E5071B-01

S E R V I C E N O T E

E5071B ENA Series Network Analyzer, 300 kHz to 8.5 GHz

Handler I/O Port Malfunction Due to TTL-Low Level Threshold Voltage Anomaly

Figure 1. Threshold voltage anomaly

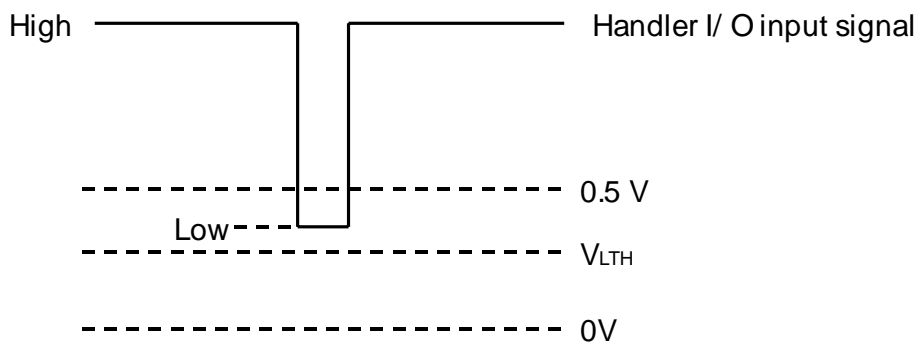
The 24-bit handler I/O of the E5071B units with the specified serial numbers may not function normally. Due to the possible threshold-voltage anomaly of TTL input circuit at either of the I/O pins 2, 18 and 22 through 29, the handler I/O port may ignore the “Low” state of control input signals. When the threshold voltage for TTL-Low level is too low (lower than 0.5 V), it is possible that control input signal does not cross the threshold voltage (V_{LTH}) though the “Low” level of the signal is within the recommended voltage range (0 V to 0.5 V). As a result, a handler interface error occurs. See Figure 1.

When the threshold voltage of the handler I/O (either of the I/O pins) is too low, replace the A23 Handler I/O board with new one (P/N E5070-61006).
